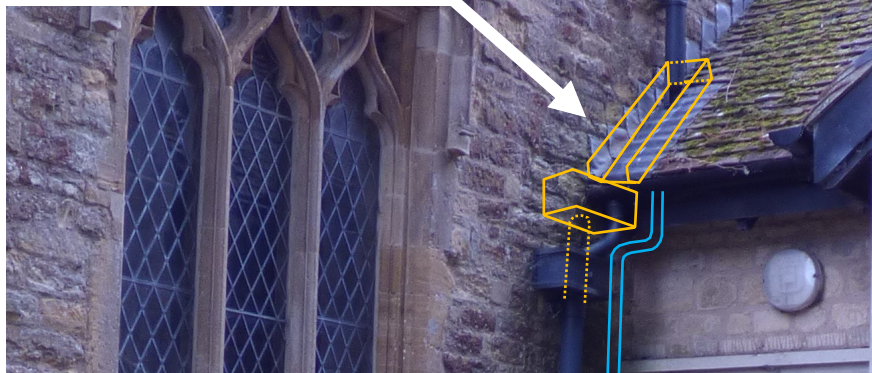
This is currently the only outlet for the north slope above.

Provide dedicated lead chute and raise hopper + existing CI pipe to eaves level to accept upper level rainwater without surcharging adjacent eaves gutter.

Reposition the running outlet on the extension eaves gutter and provide separate CI downpipe to gully at base

Revise existing gully at ground level to create wider inlet suitable for both adjacent downpipes.
